**PITTSBURG UNIFIED SCHOOL DISTRICT
HIGHLANDS ELEMENTARY SCHOOL
PORTABLES REPLACEMENT PROJECT**

**BID ADDENDUM NO. 3
May 5, 2026**

PROJECT: Highlands Elementary School – Portables Replacement
4141 Harbor St, Pittsburg, CA 94565

A1.03

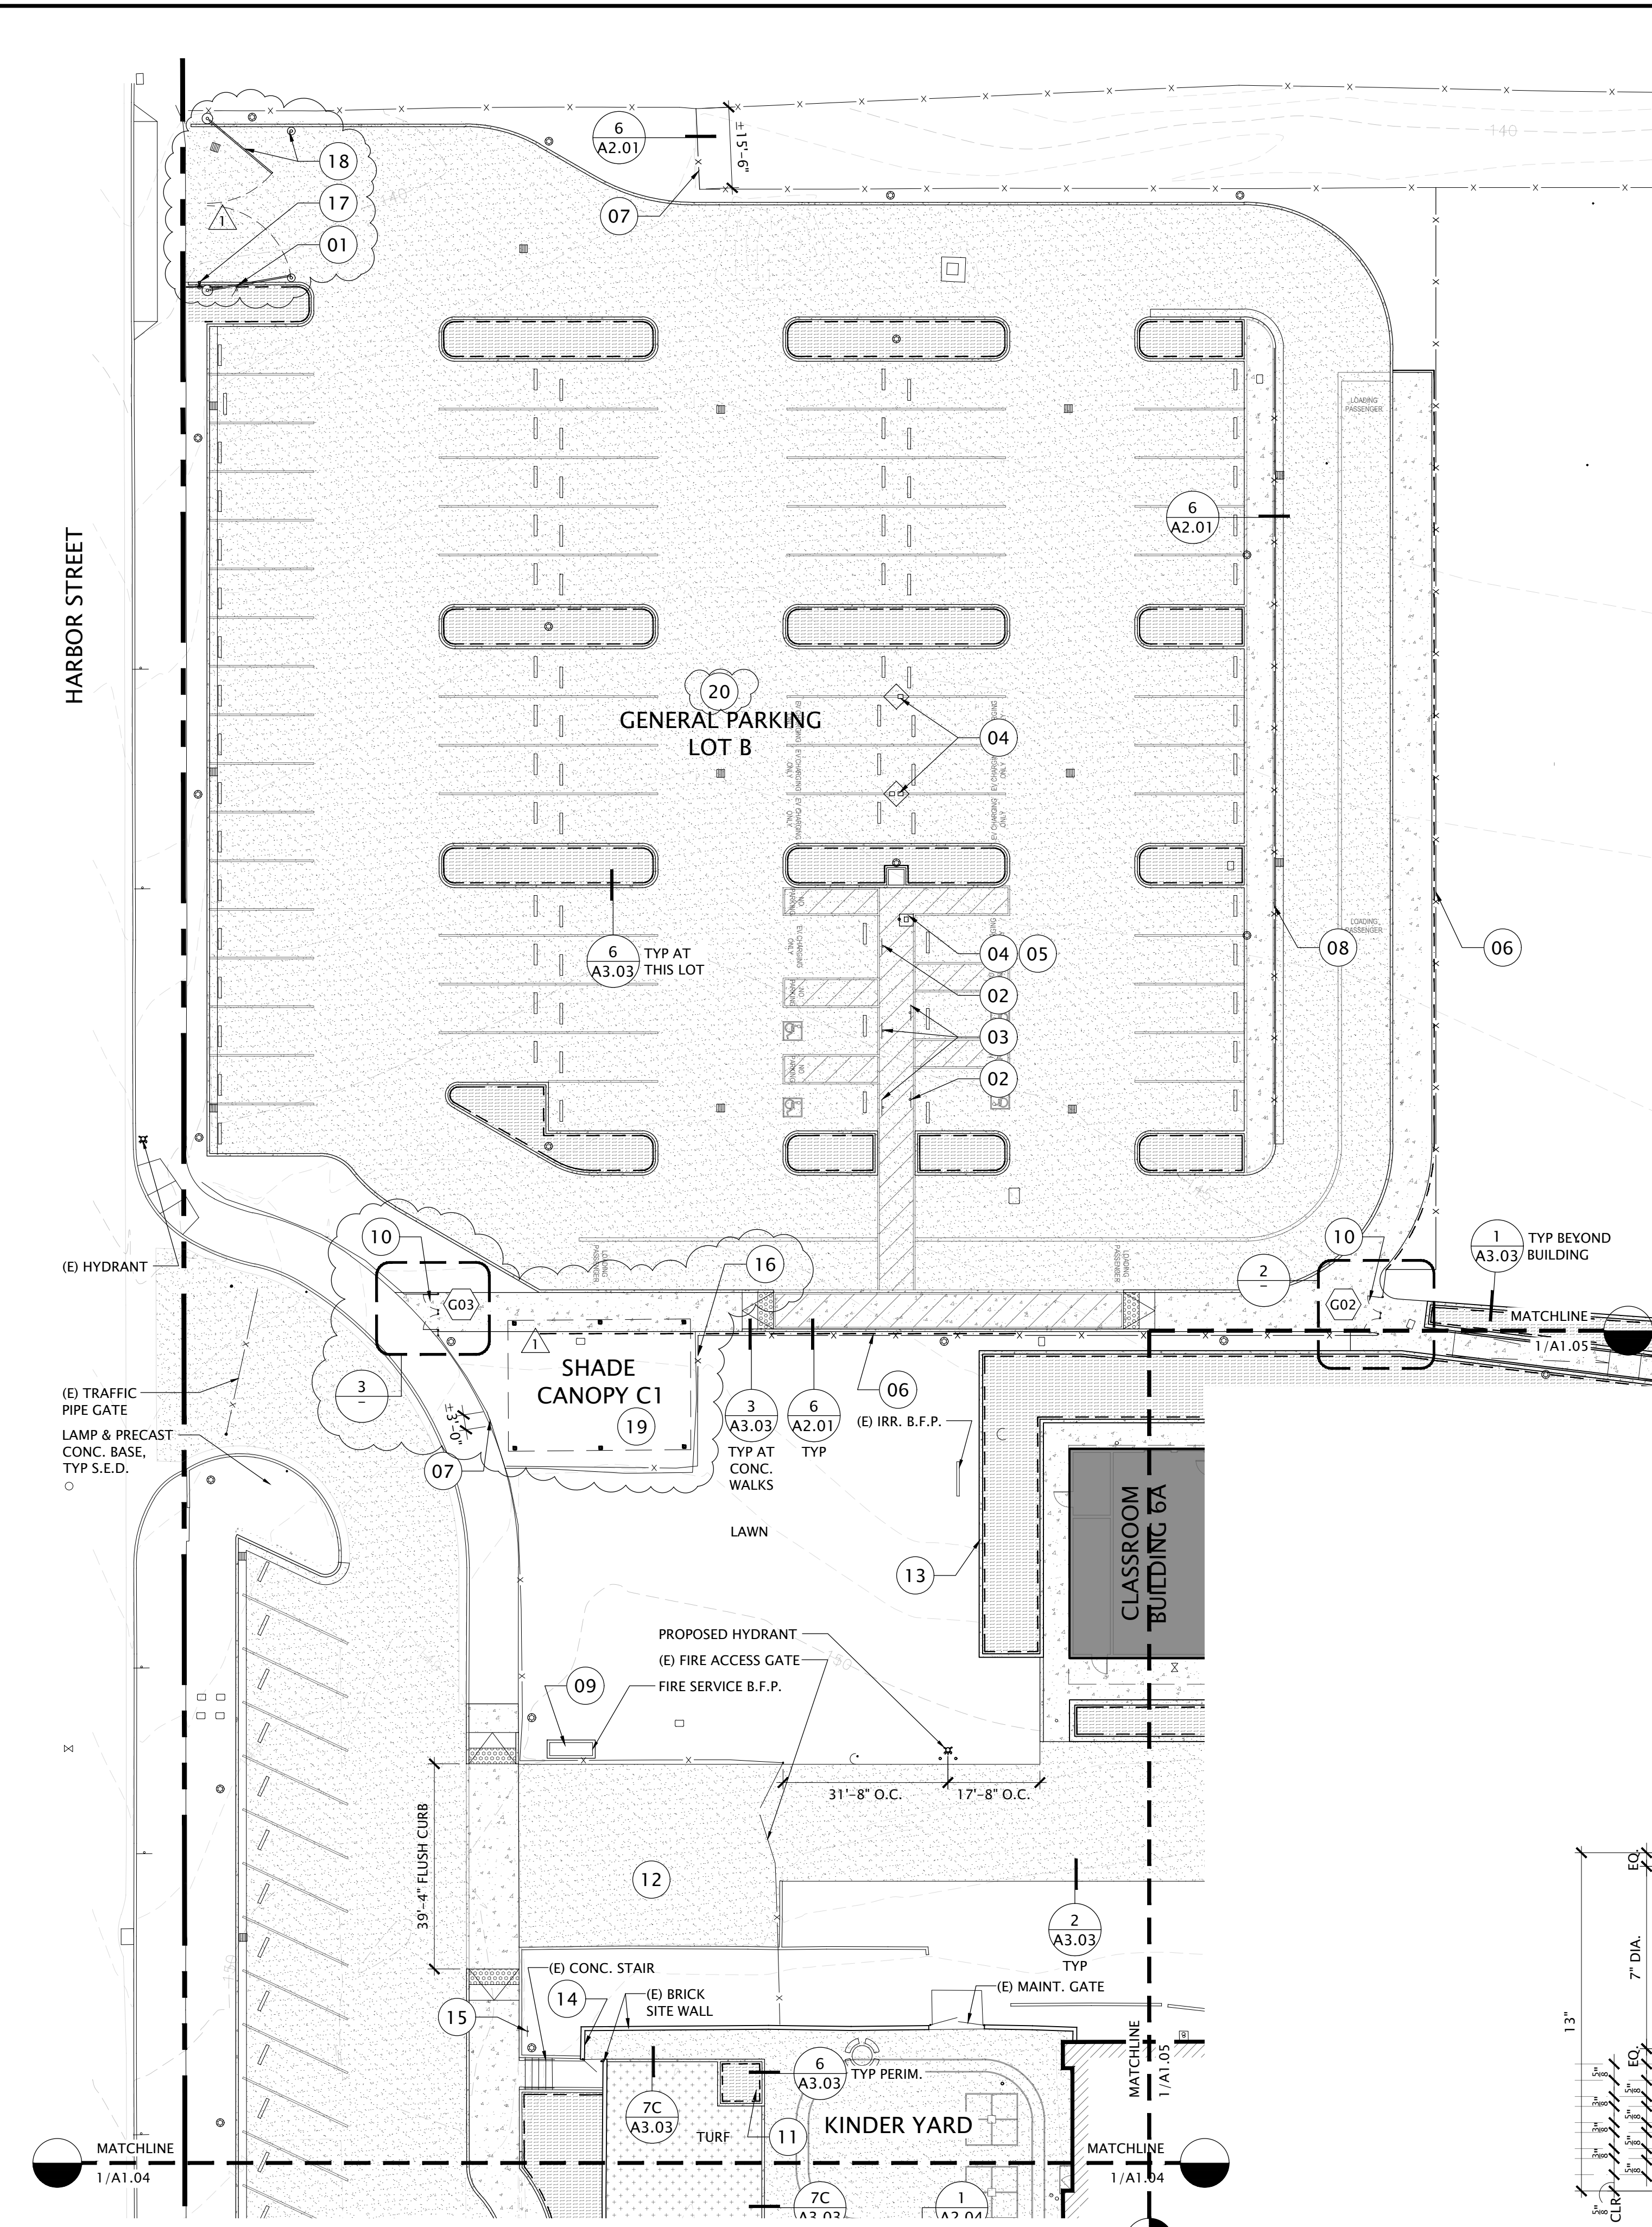
Reference: A1.03 - ENLARGED SITE PLAN: HARBOR STREET NORTH
Attachment: A1.03 - ENLARGED SITE PLAN: HARBOR STREET NORTH
Description: 1. Add Keynote 16 to read as follows; "Infill fencing segment between existing and new fence segments."
2. Add Keynote 17 to read as follows; "Provide & install knox box per 2/A2.02b."
3. Add Keynote 18 to read as follows; "Provide & install pipe rail gate at parking lot drive aisle per 1/A2.02b."
4. Add Keynote 19 to read as follows; "Slurry seal over existing asphalt paving to remain below shade canopy per attached Specification Section 32 12 37 SEAL COAT."
5. Add Keynote 20 to read as follows; "Provide and install Tensar BX1100 geo grid or equal beneath base rock at all parking lot and fire lane new asphalt, S.C.D 1/C/3.02."

- 16 INFILL FENCING SEGMENT BETWEEN EXISTING AND NEW FENCE SEGMENTS.
- 17 PROVIDE & INSTALL KNOX BOX PER 2/A2.02b.
- 18 PROVIDE & INSTALL PIPE RAIL GATE AT PARKING LOT DRIVE AISLE PER A/2.02b.

- 19 SLURRY SEAL OVER EXISTING ASPHALT PAVING TO REMAIN BELOW SHADE CANOPY.
- 20 PROVIDE AND INSTALL TENSAR BX1100 GEO GRID OR EQUAL BENEATH BASE ROCK AT ALL PARKING LOT AND FIRE LANE NEW ASPHALT, S.C.D. 1/C3.02.

A1.04

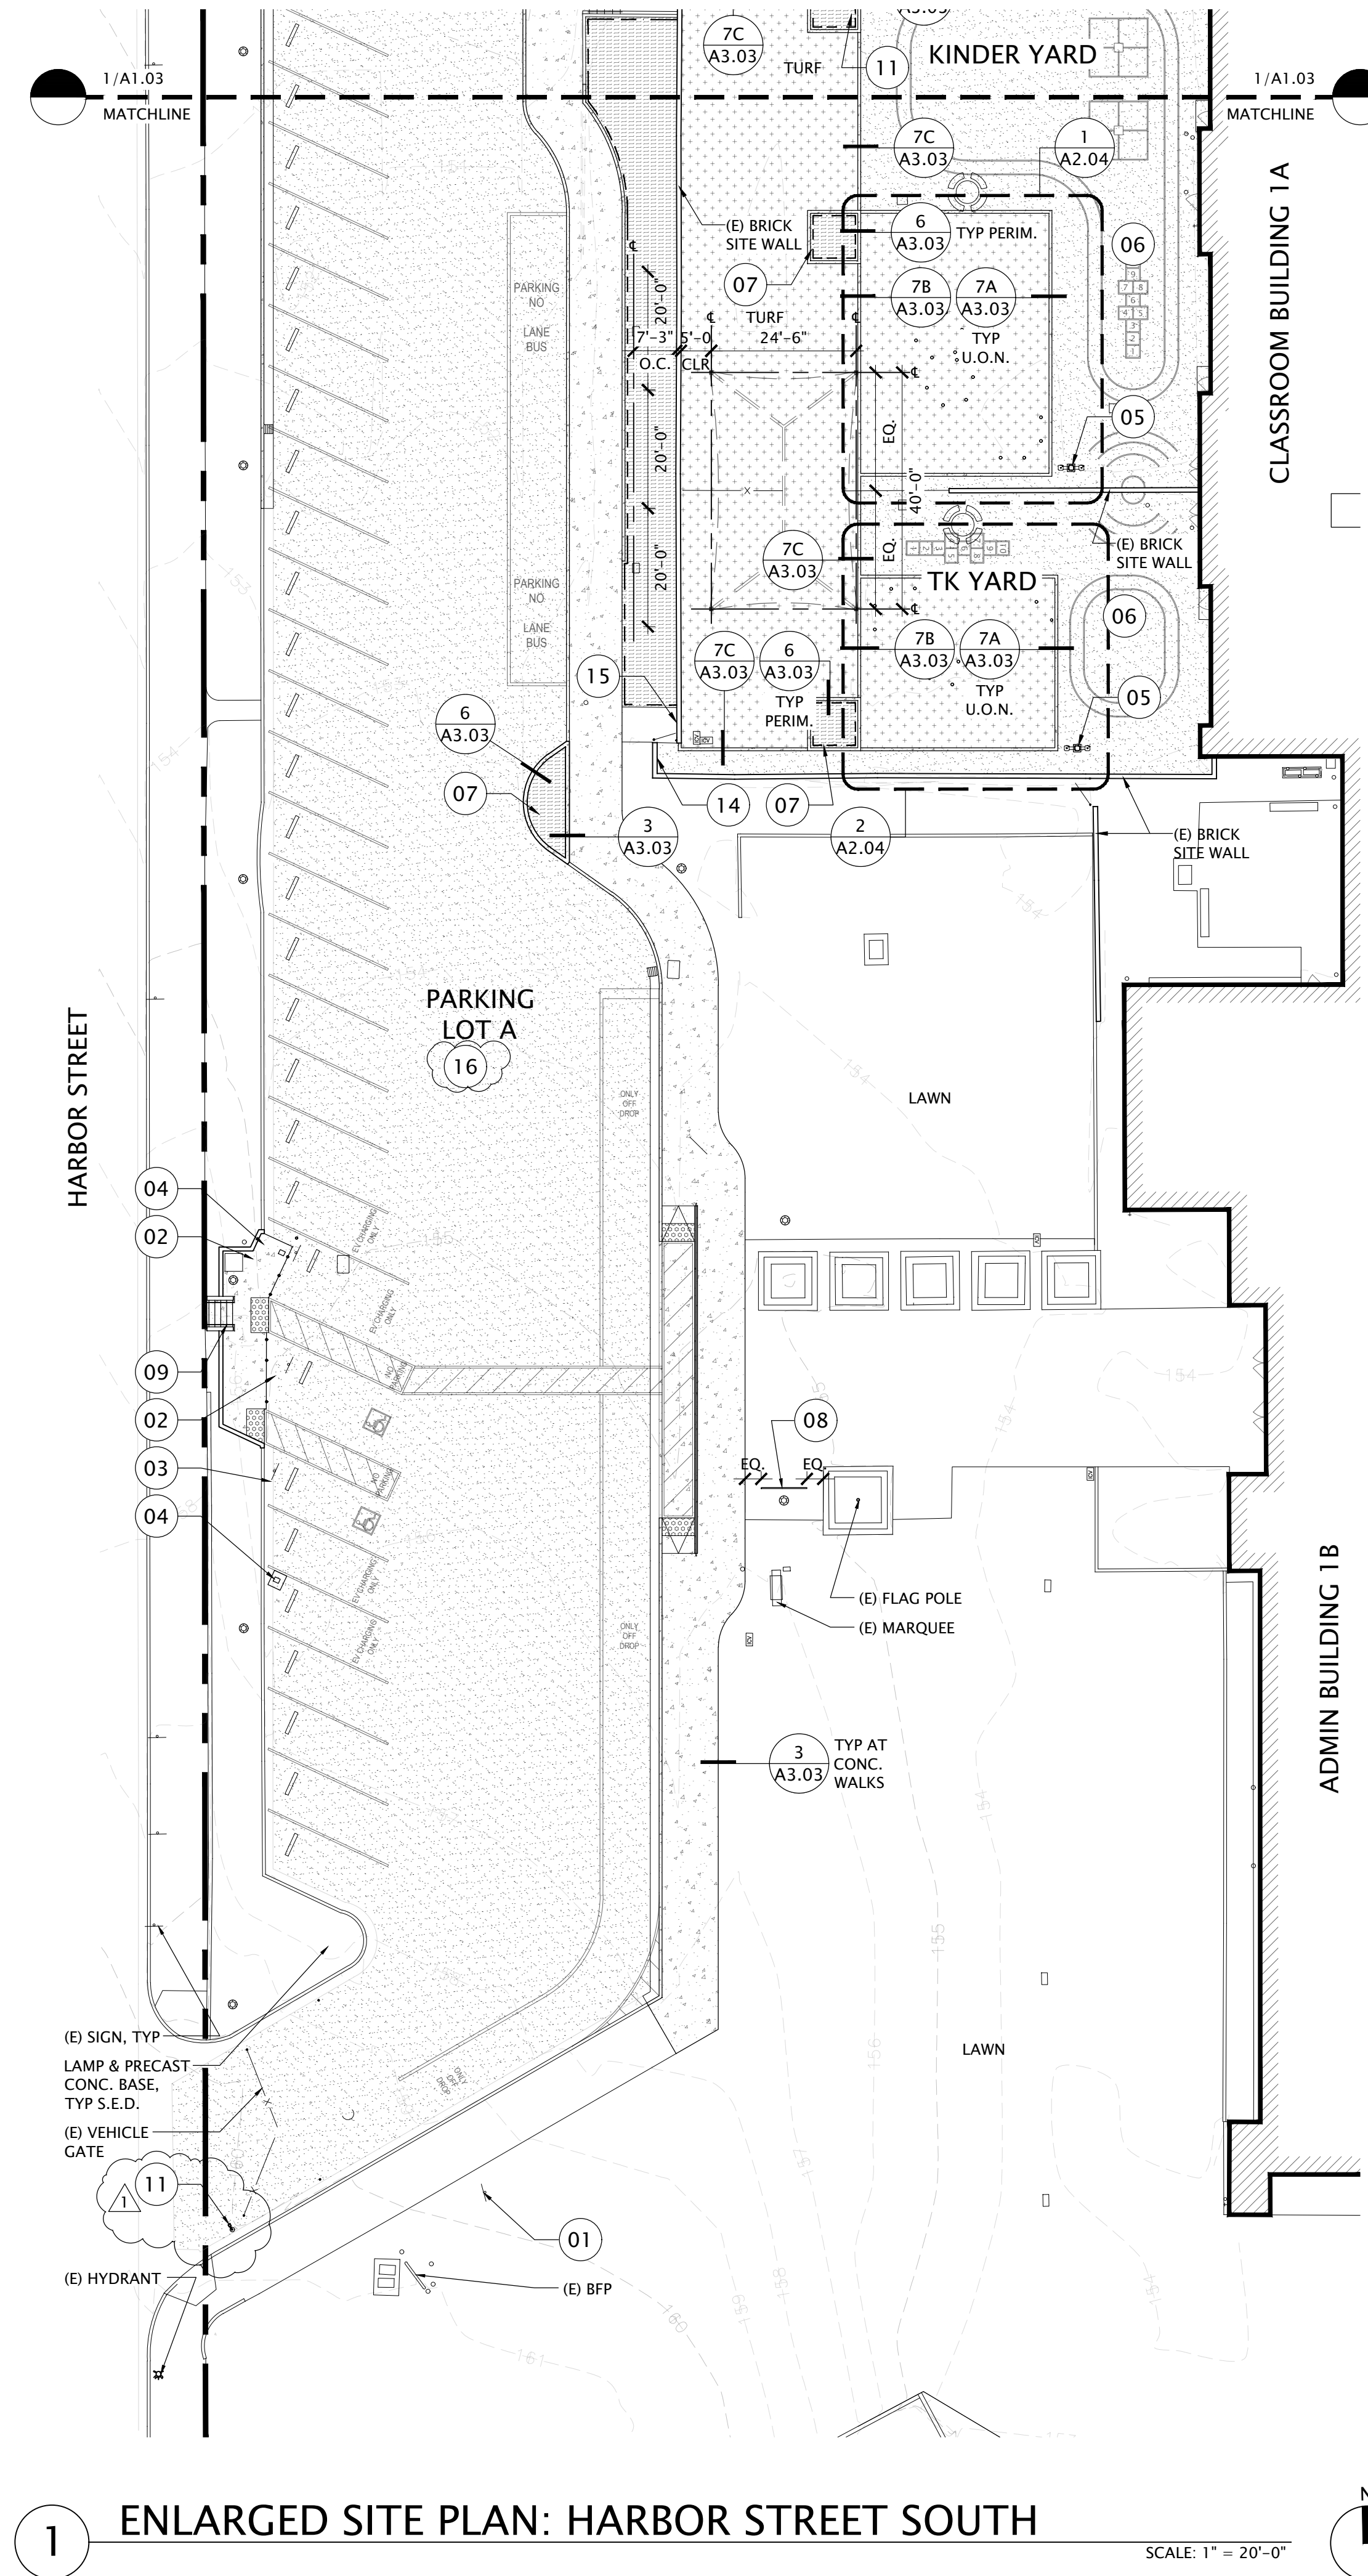
Reference: A1.04 - ENLARGED SITE PLAN: HARBOR STREET SOUTH
Attachment: A1.04 - ENLARGED SITE PLAN: HARBOR STREET SOUTH
Description: 1. Add Keynote 11 to read as follows; "Provide & install knox box per 2/a2.02b."
2. Add Keynote 16 to read as follows; "Provide and install Tensar BX1100 geo grid or equal beneath base rock at all parking lot and fire lane new asphalt, S.C.D 1/C/3.02."

- 09 REPLACE EXISTING CONC. SITE STAIR IN-KIND PER 5/A1.03.
- 11 PROVIDE & INSTALL KNOX BOX PER 2/A2.02b.
- 14 PROVIDE & INSTALL NON-ACCESSIBLE EXIT SIGNAGE PER 6/A1.03 AT EXISTING BRICK SITE WALL.

- 16 PROVIDE AND INSTALL TENSAR BX1100 GEO GRID OR EQUAL BENEATH BASE ROCK AT ALL PARKING LOT AND FIRE LANE NEW ASPHALT, S.C.D. 1/C/3.02
